Model: Kir-C ADF (DF72)		Date: 24-May-01	No.: MB387001
Modified Article: Parts Catalog Correction		Prepared by: K. Miura	
From: Technical Services Dept., GTS Division			
Reason for Modification:	<input checked="" type="checkbox"/> Parts catalog correction <input type="checkbox"/> To facilitate assembly <input type="checkbox"/> Part standardization	<input type="checkbox"/> Vendor change <input type="checkbox"/> To improve reliability <input type="checkbox"/> Other	<input type="checkbox"/> To meet standards ()

Please correct your Parts Catalog as follows:

Page 9

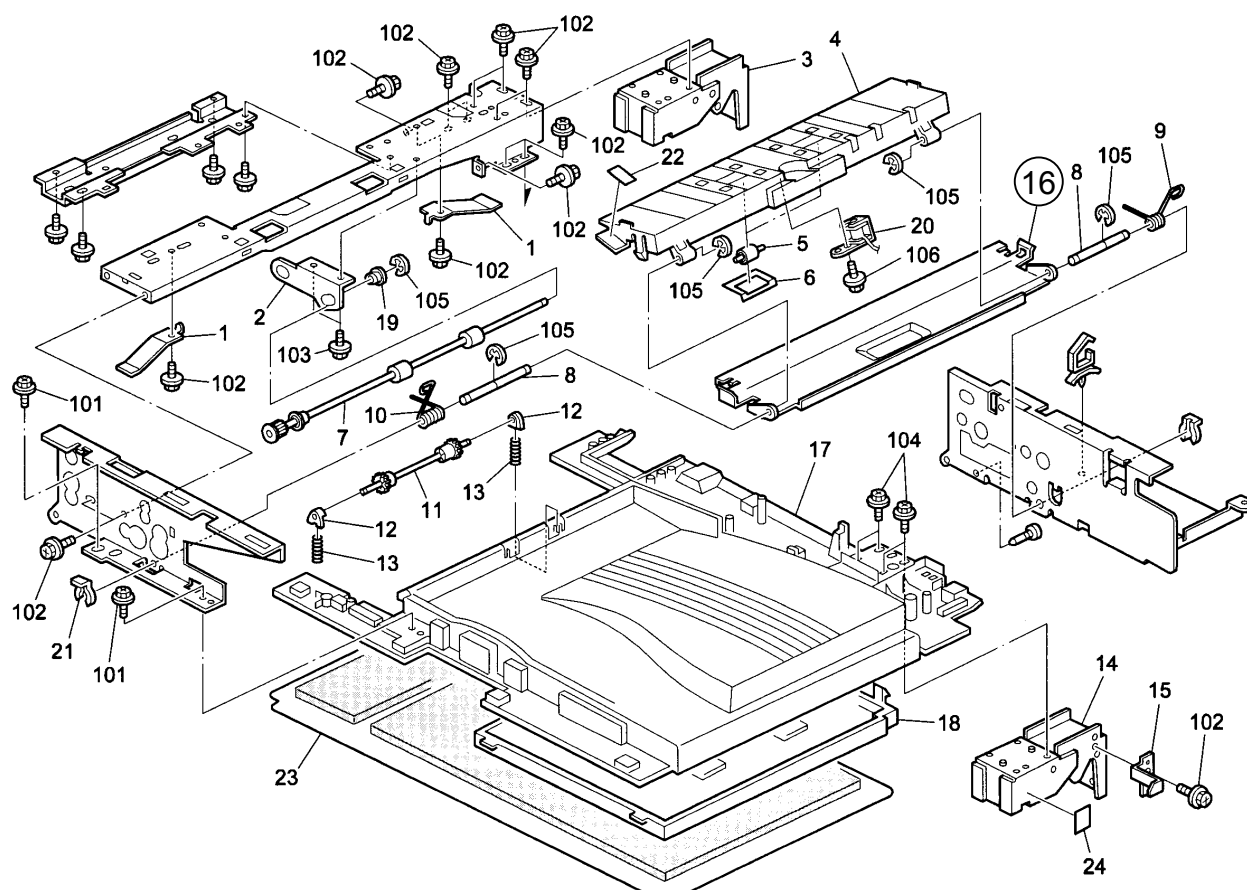
- Part Number Change -

Old part number	New part number	Description	Q'ty	Index	Note
B3873413	B3873410	Cover – Exit Guide Plate	1	16

Page 11

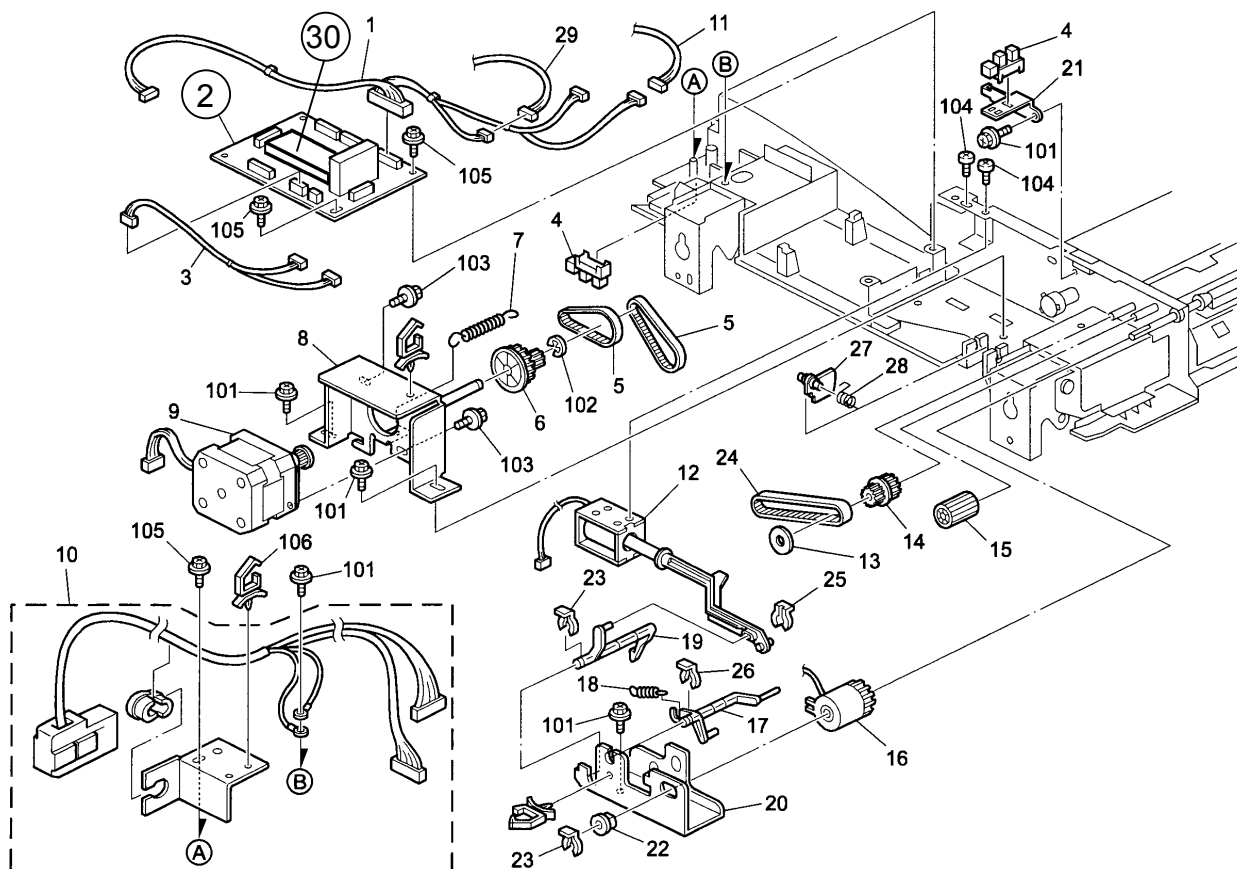
- Part Number Change -

Old part number	New part number	Description	Q'ty	Index	Note
B3875500	B3875510	Main Control Board	1	2

- Addition -

Part number	Description	Q'ty	Index	Note
B3875660	ADF ROM	1	30

Page 2, 3

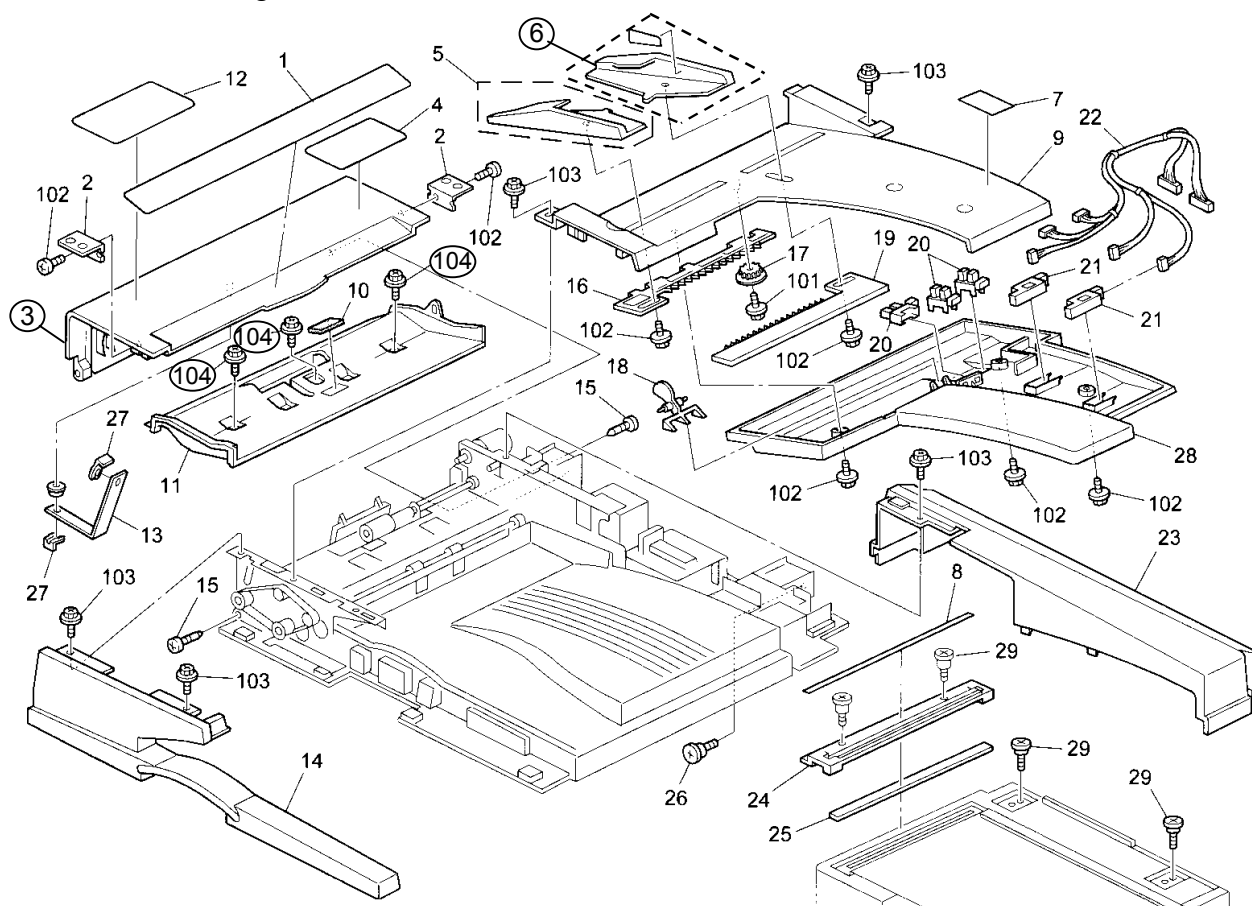
- Add the following part -

Part number	Description	Q'ty	Index	Note
04513006B	Tapping Screw – M3x6		104

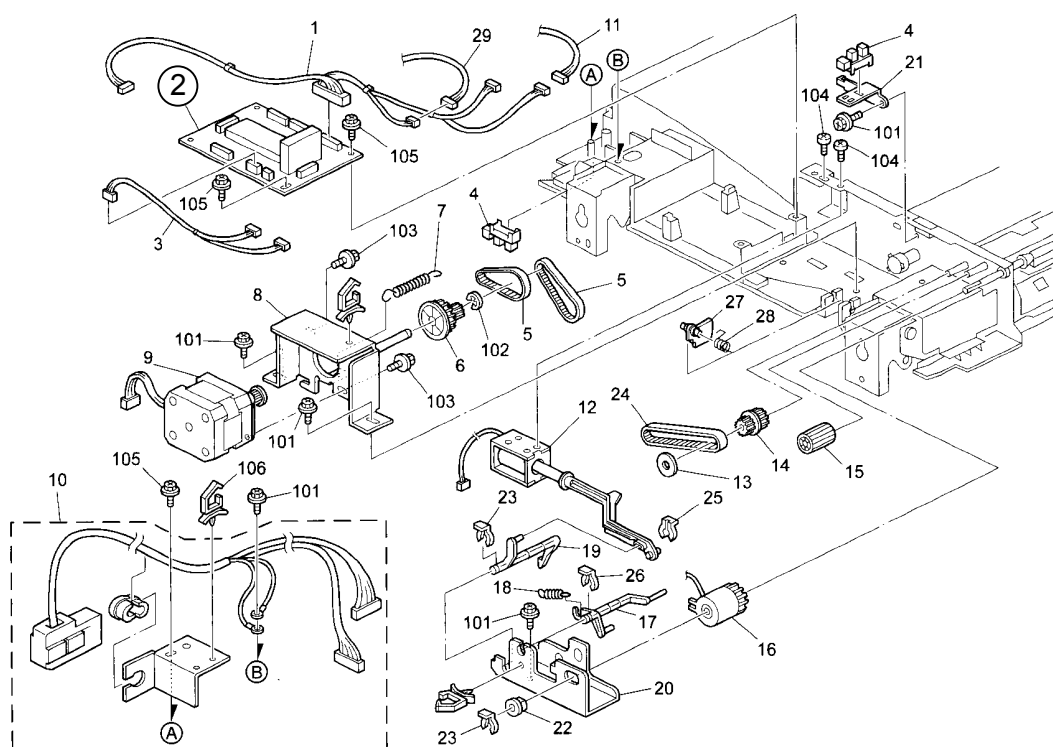
When feeding custom size originals with the ADF (B387), the second original will jam when the actual length is from 118 mm to 172mm. To ensure this does not occur, the following part has been changed. Please refer to RTB #RB040014 for further details.

Old part number	New part number	Description	Q'ty	Int	Page	Index	Note
B3875510	B3875520	Main Control Board	X/O	1	11	2

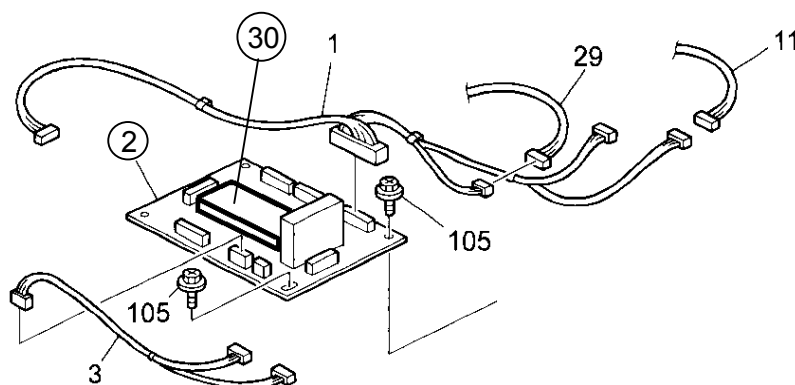
To prevent original jams, the following part has been changed:
 For details, refer to RTB #RB040008.

Old part number	New part number	Description	Q'ty	Int	Page	Index	Note
B3875520	B3875530	Main Control Board	1	X/O	11	2	
B3875660	B3875680	ADF ROM	1	X/O	11	30

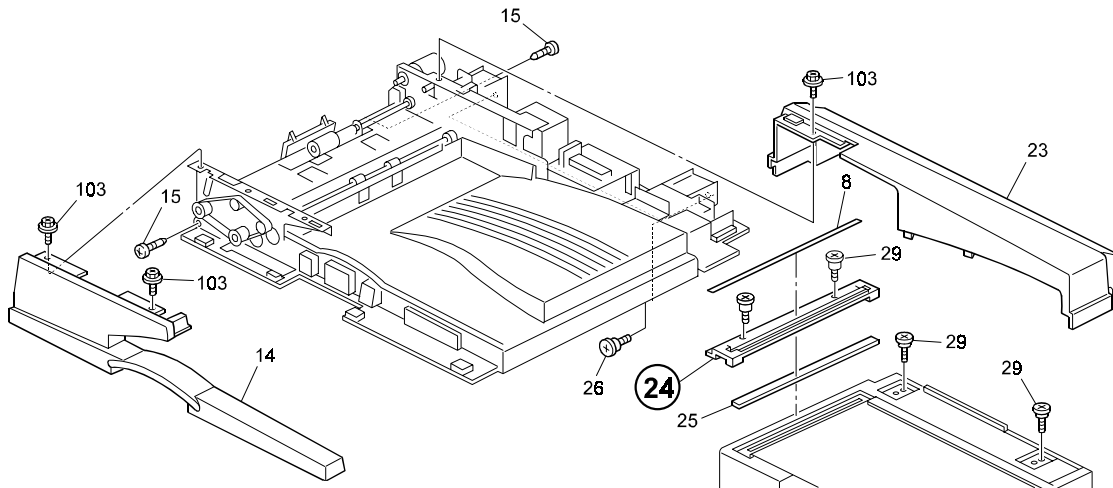
The shape of the Original Scale has been changed to ensure smoother feed of originals.

Old part number	New part number	Description	Q'ty	Int	Page	Index	Note
B3867101	B3867102	Original Scale	1	O/O	3	24

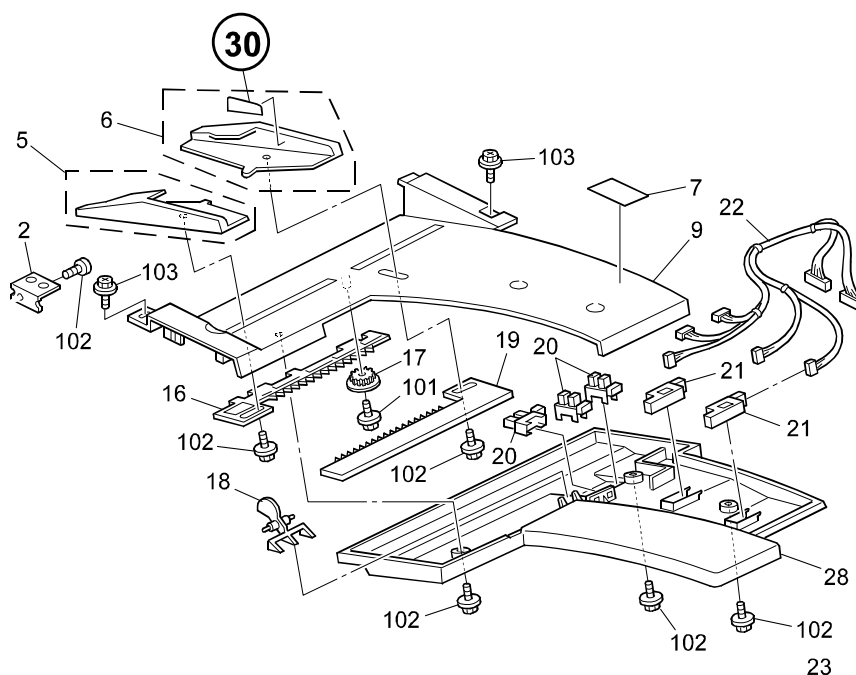
Please add the following part to your Parts Catalog:

New part number	Description	Q'ty	Page	Index	Note
B3876042	Side Fence Decal	1	3	30

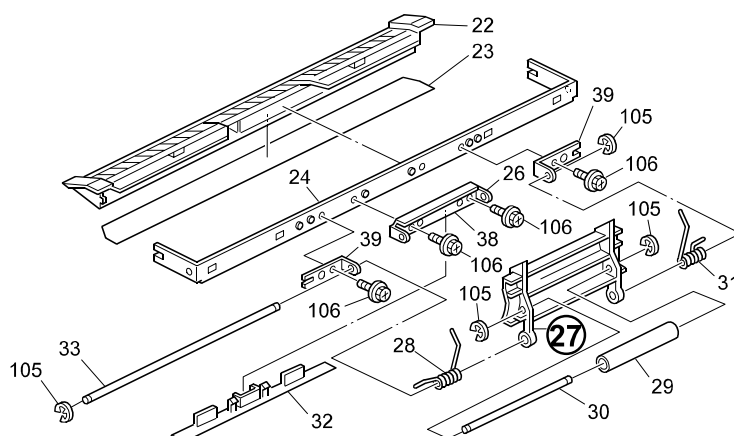
The following has been changed to ensure that curled originals do not contact the Transport Driven Roller Cover and jam.

Old part number	New part number	Description	Q'ty	Int	Page	Index	Note
B3873316	B3873322	Cover - Transport Driven Roller	1	X/O	5	27

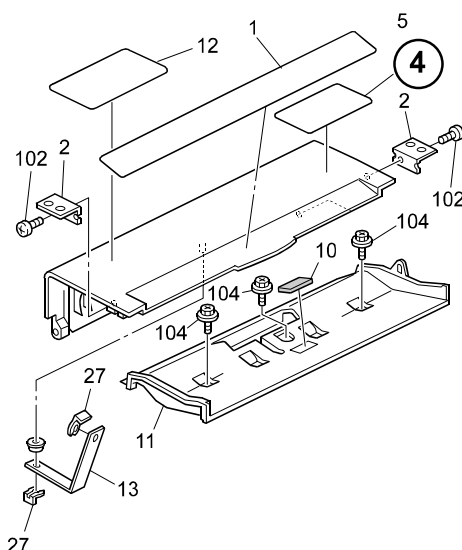
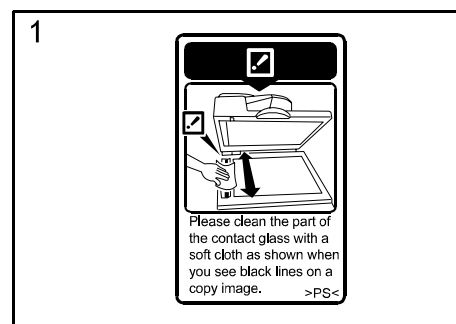
Explanations in four display languages have been added to the following decal.

Old part number	New part number	Description	Q'ty	Int	Page	Index	Note
B3796063	G5646077	Exposure Glass Decal	1	X/O	3 13	4 1

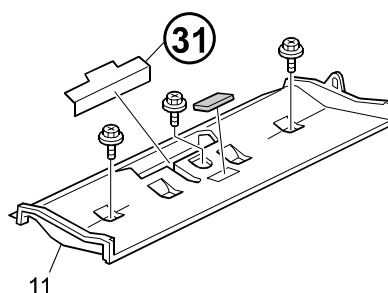
The following has been added to ensure the trailing edge does not impact with the separation roller when feeding 30 or more originals.

Old part number	New part number	Description	Q'ty	Int	Page	Index	Note
	B3872321	Separation Guide Mylar	1		3	31

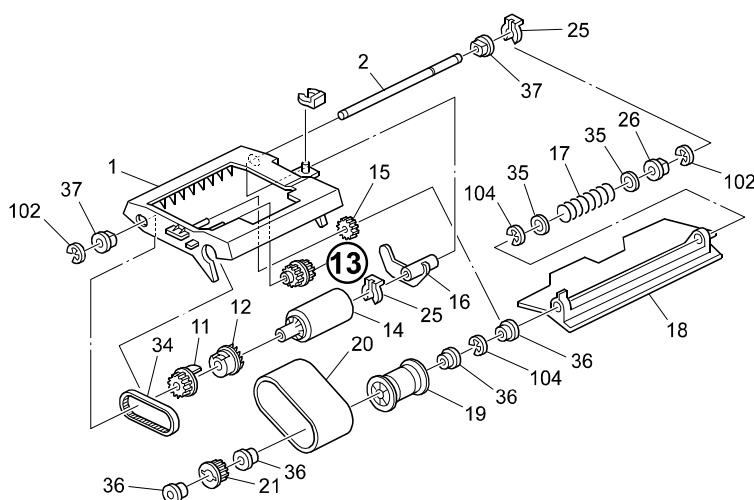
The following has been changed due to parts standardization with the DF71.

Old part number	New part number	Description	Q'ty	Int	Page	Index	Note
A8592168	G4123831	Pulley - 22Z	1	O/O	5	13
